**DRAFT Preliminary Review:
Navy Groundwater Flow Model
for the Navy Red Hill Facility**

*The Department of Health Hawaii (DOH)
Technical subject matter experts
Robert Whittier, Don Thomas, G.D. Beckett & Anay Shende*

February 12, 2021

GW Elevation Variance – Transient Models

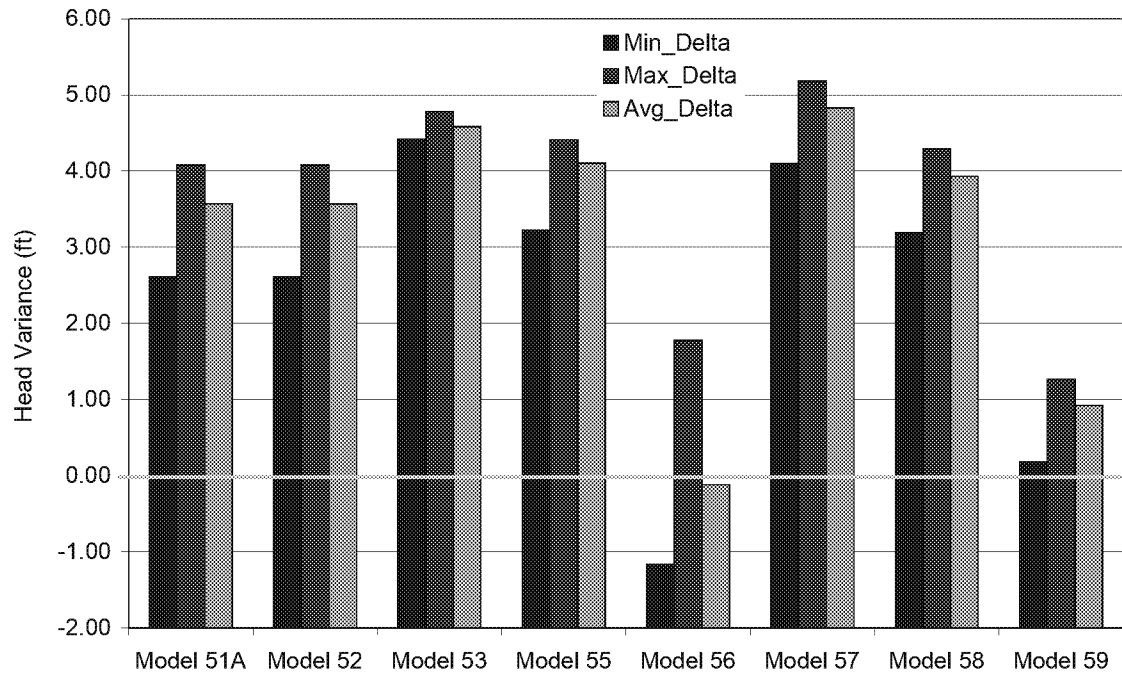
Modeled Groundwater Elevations Compared to Actual Synoptic Data
Verification Model Variances to Measured Red Hill Area Well

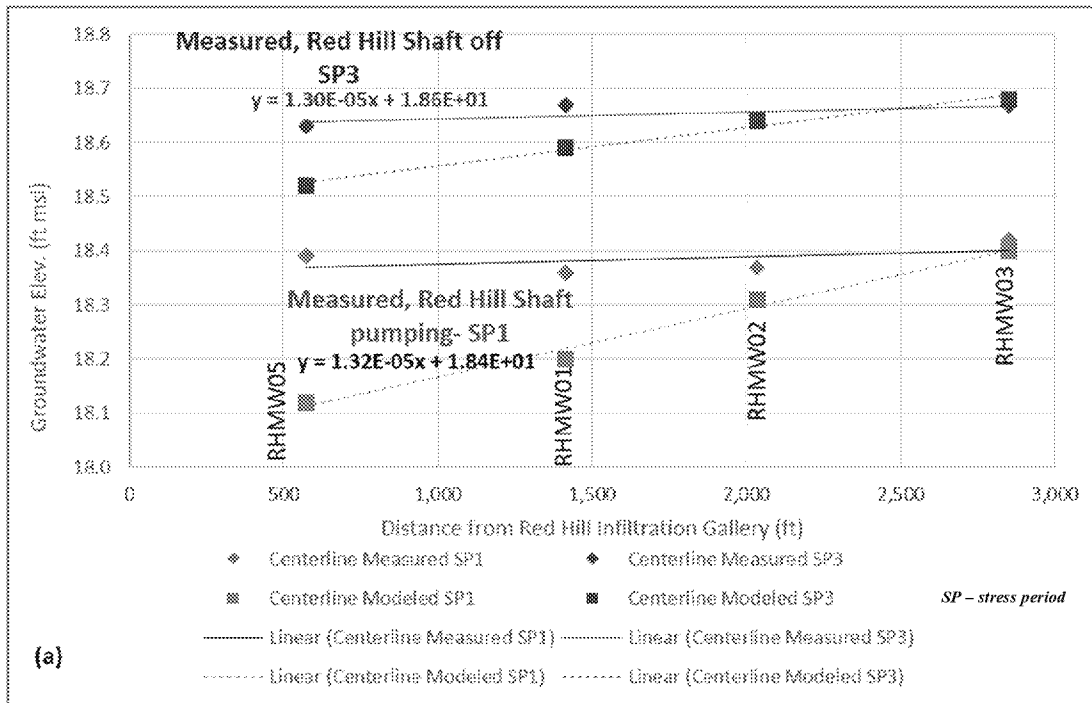
Modeled Gradients Are Too Large (Red Hill area, no gradient change under pumping)
